# ADDITIONAL MUTE-OPTO-RELAIS

TITLE: OUT-JACKS_for_MD-PRE_V1.73_ERRATA	
Document Number:	REV:
Date: 07.01.2008 09:10:44	Sheet: 1/1

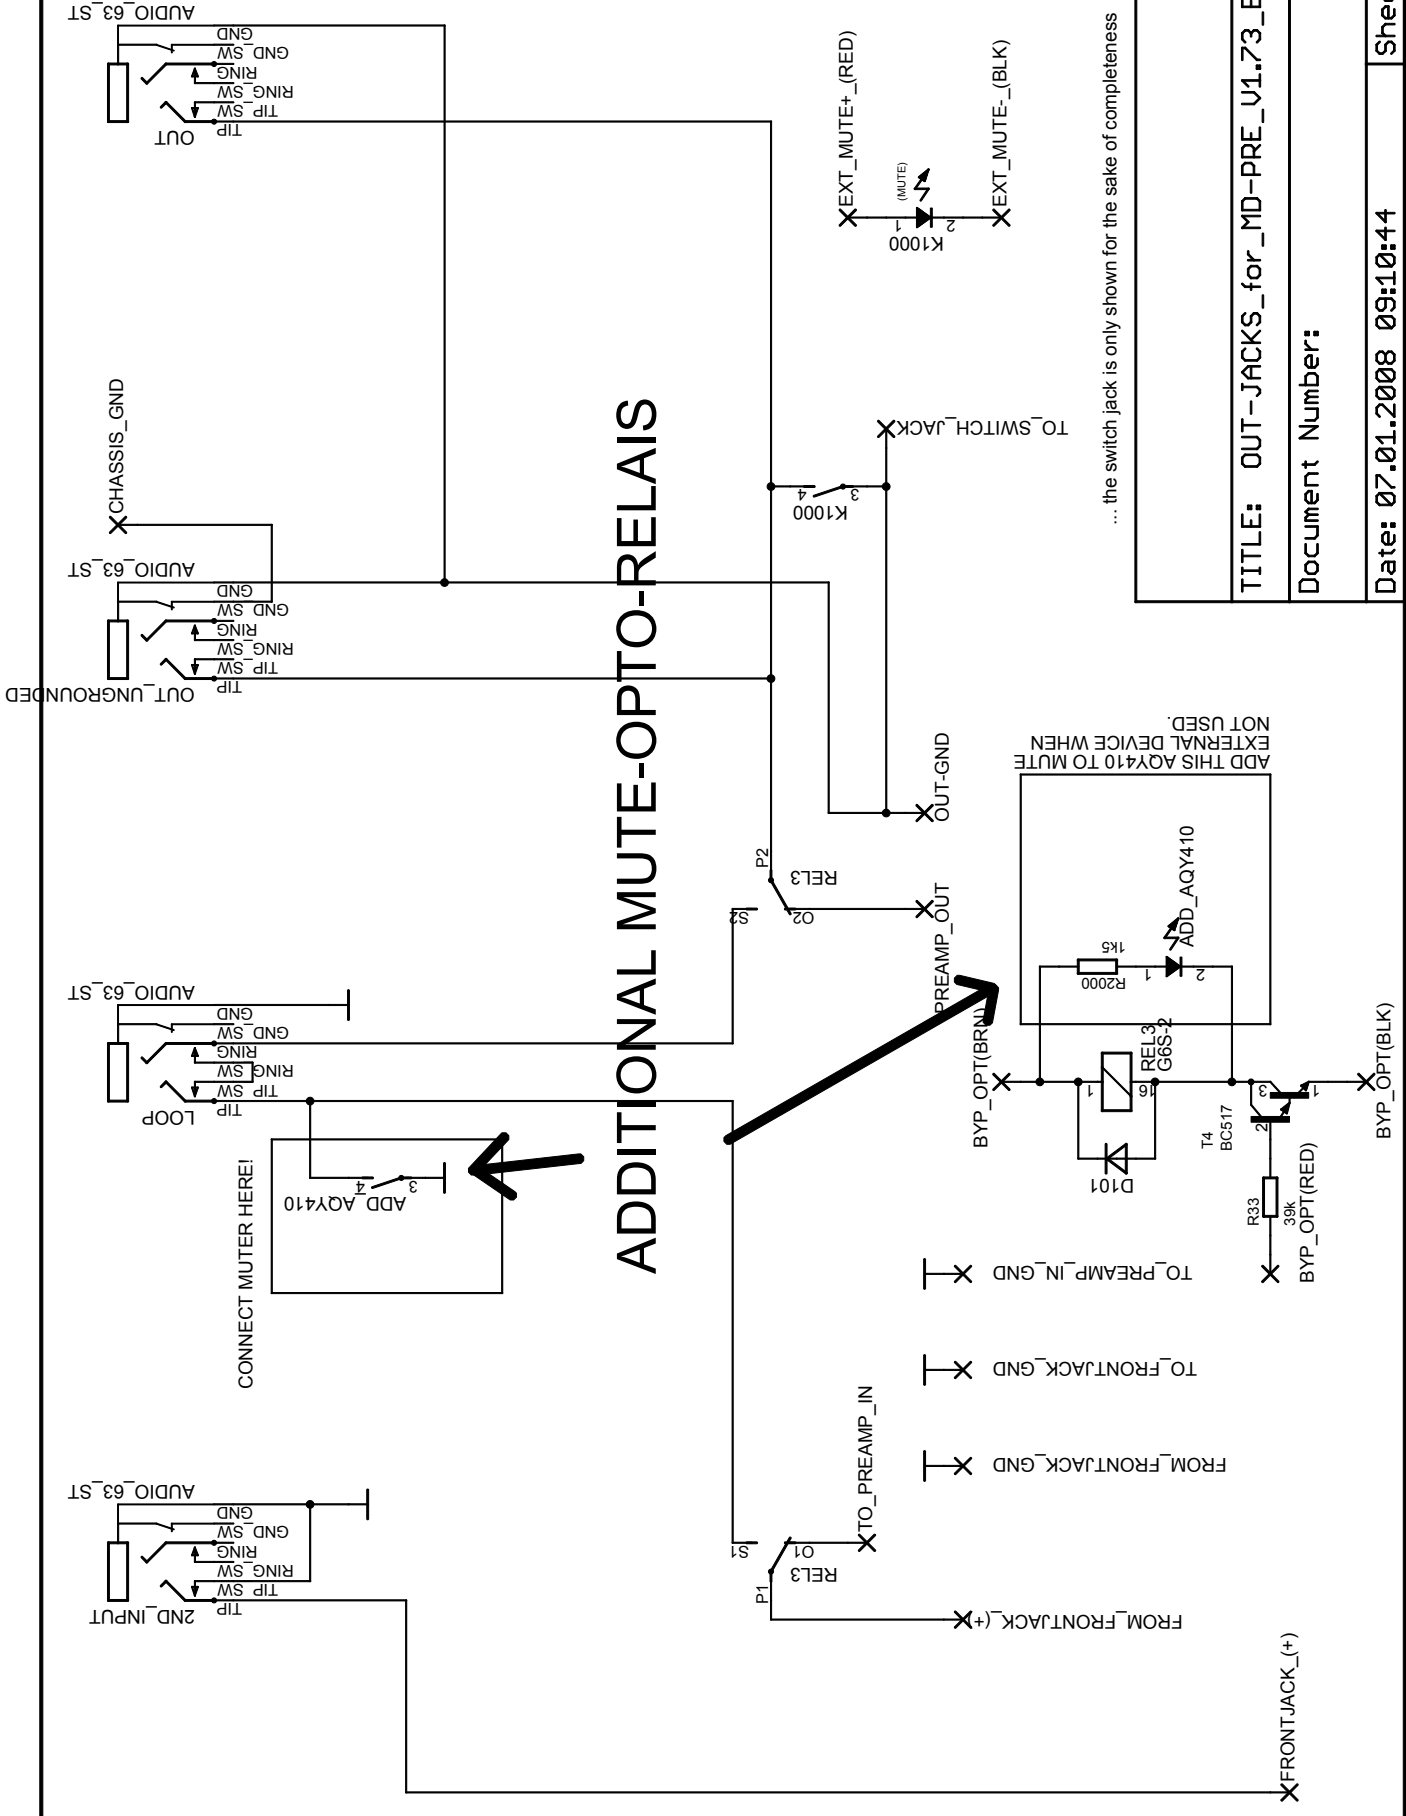
... the switch jack is only shown for the sake of completeness
